TOWN OF VERNON
Planning & Zoning Commission (PZC)
Meeting Notice
Thursday, September 2, 2021 7:30 PM
Town Hall
14 Park Place, 3rd Floor
Council Chambers*
Vernon, CT

PZ 2021-08 is an application of A. Vets Real Estate, LLC requesting site plan modification approval for a 1.19-acre parcel located at 965 Hartford Tpke (Assessor ID 26, Block 72, Parcel 0031H) and a .43-acre portion of a parcel located at 933 Hartford Tpke (Assessor ID 26, Block 72, Parcel 0031J). A special permit to allow over 40% lot coverage is also requested.

Re: Site Plan of Development, A. Vets Real Estate, 965 Hartford Turnpike, Vernon, Connecticut –
PZ-2021-08

EROSION & SEDIMENT CONTROL PLAN
PREPARED FOR
A. VETS REAL ESTATE, LLC
965 HARTFORD TURNPIKE
VERNON, CONNECTICUT

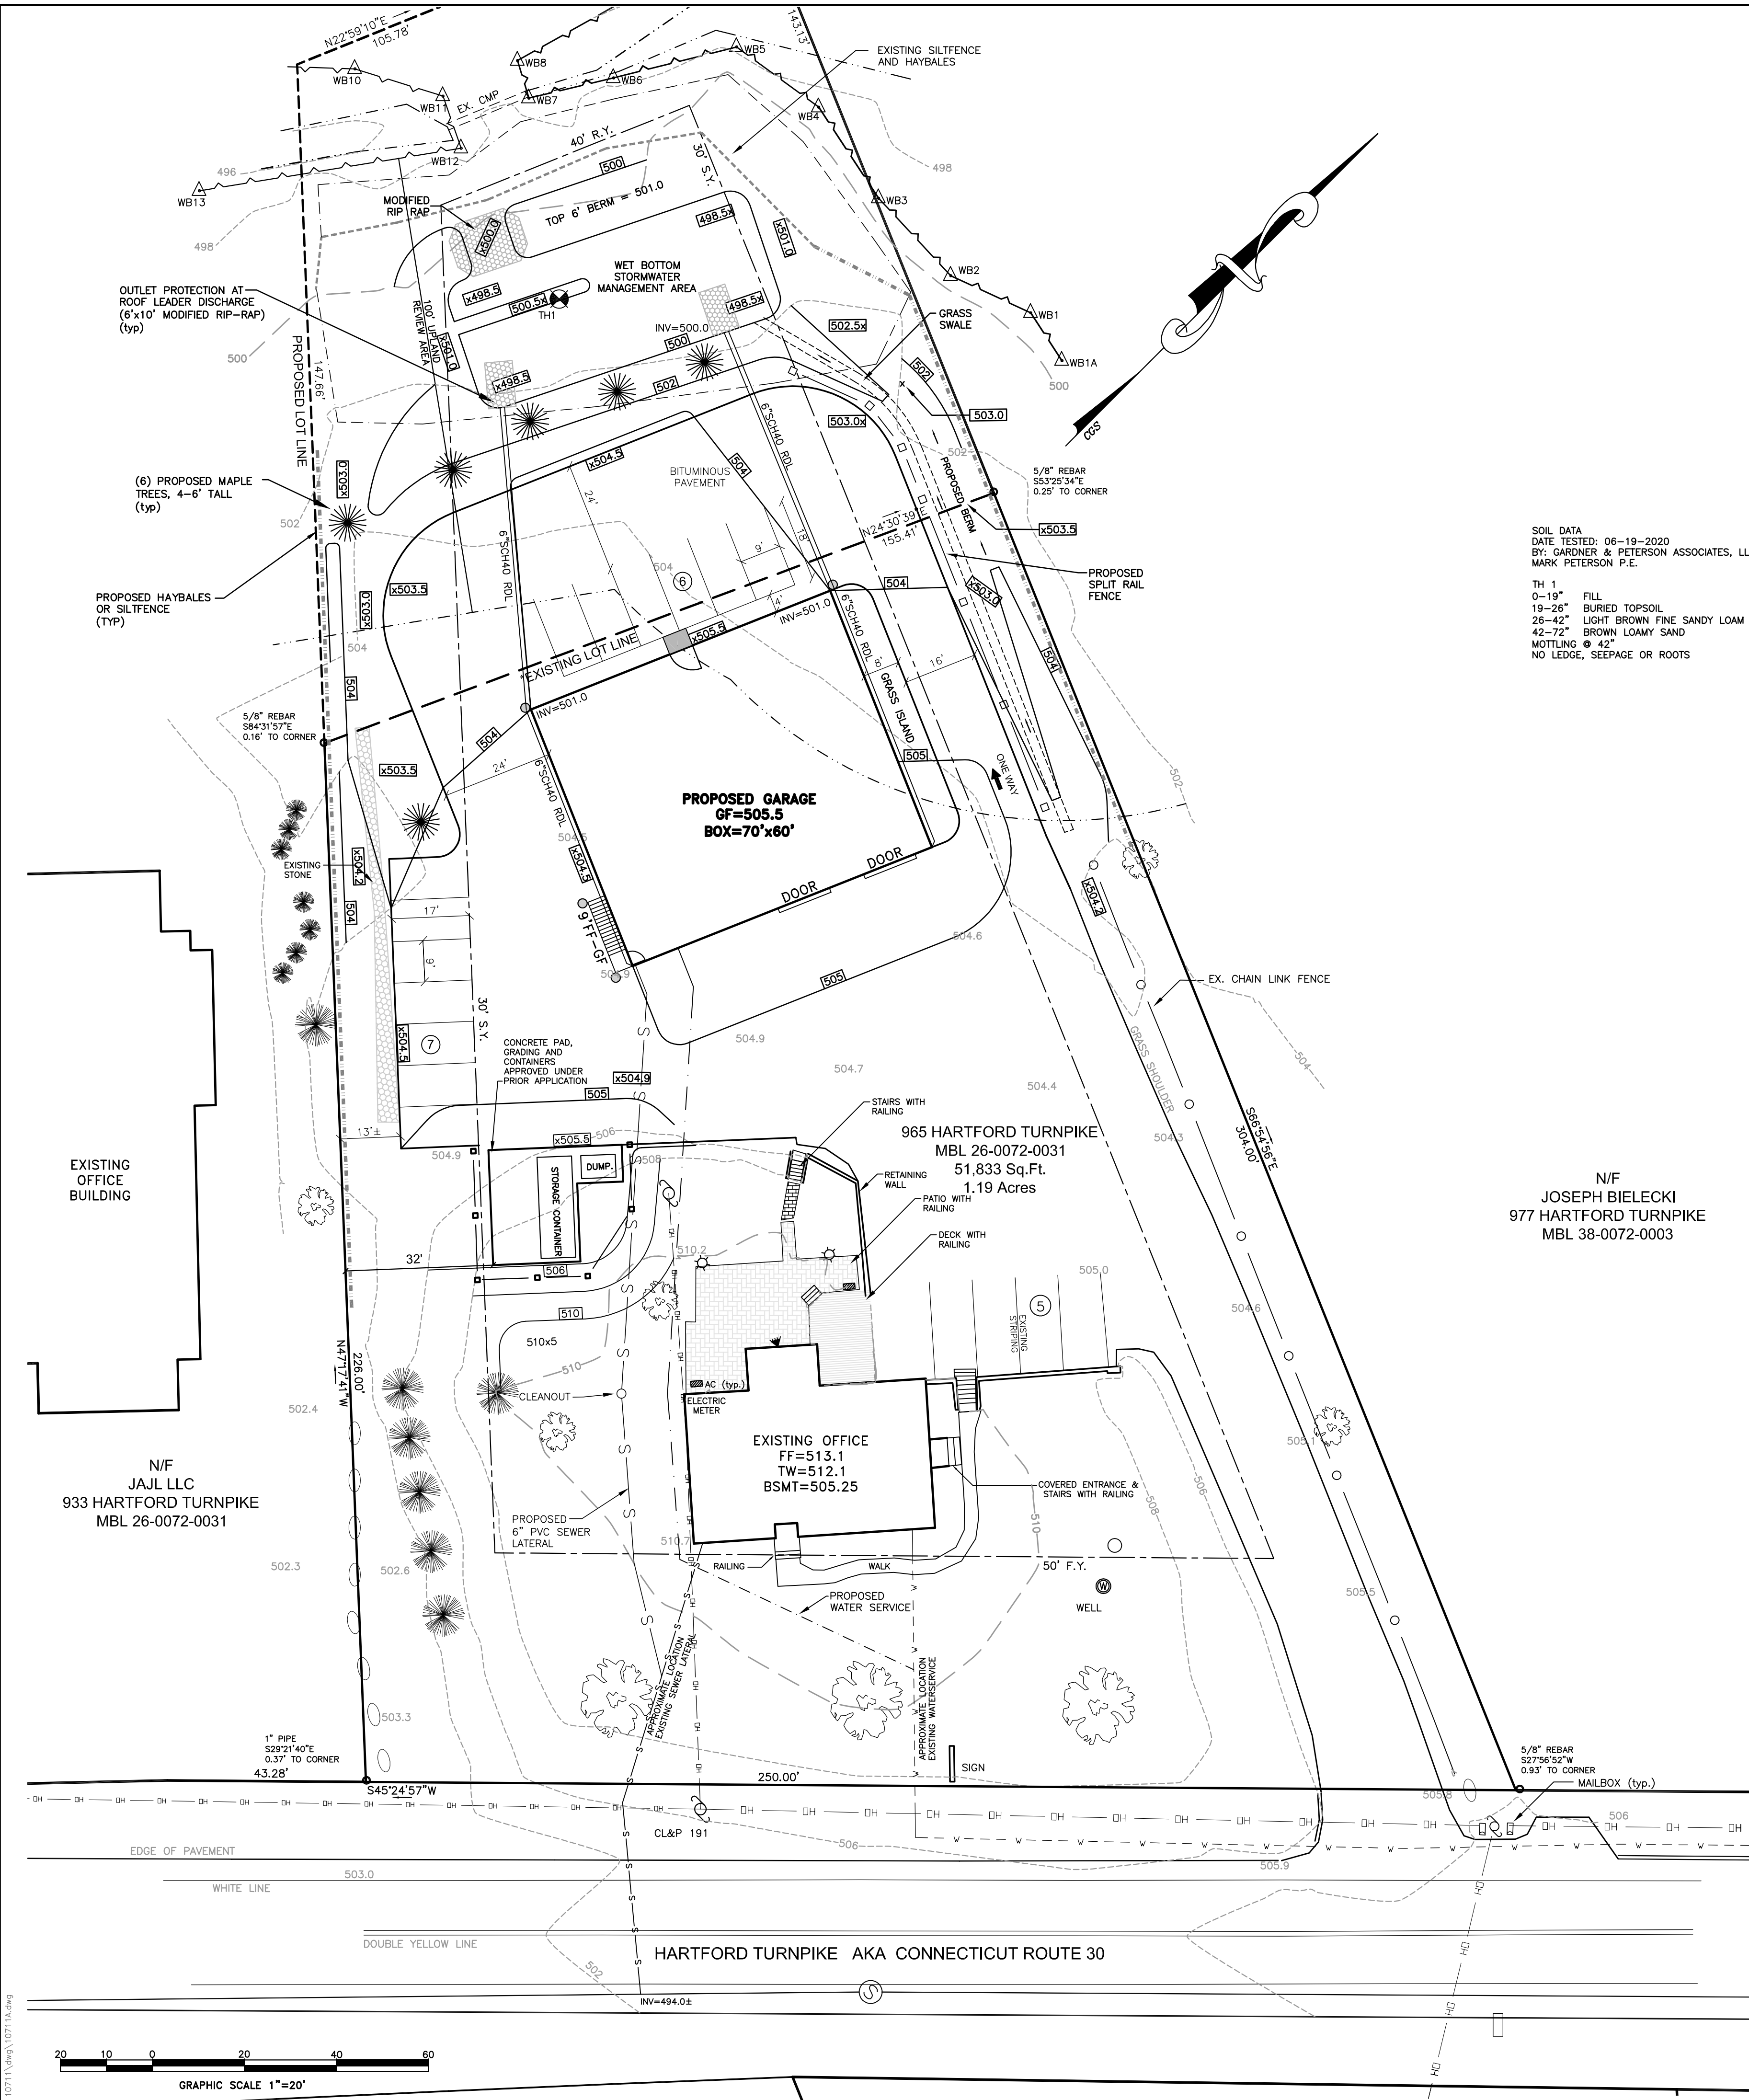
The Plan shows removal of an existing garage and proposes the construction of a larger 70' by 60' garage with associated improvements to parking and stormwater treatment. Most of the proposed improvements to parking and stormwater treatment will be built on 0.43 acres of 933 Hartford Turnpike abutting the rear of the 965 Tolland Turnpike parcel. To the north and west, a watercourse with associated wetlands borders the proposed stormwater management area. Proposed soil erosion and sediment control (E&S) measures include an anti-tracking pad and show both existing and proposed silt fence and hay bales.

The use of silt fence and hay bales as perimeter control measures is adequate and appropriate for this site. However, the "existing silt fence and hay bales" shown on the plan have not been maintained. Hay bales have deteriorated and fencing has fallen resulting in gaps.

- Repair &/or replace the existing silt fence and hay bales.
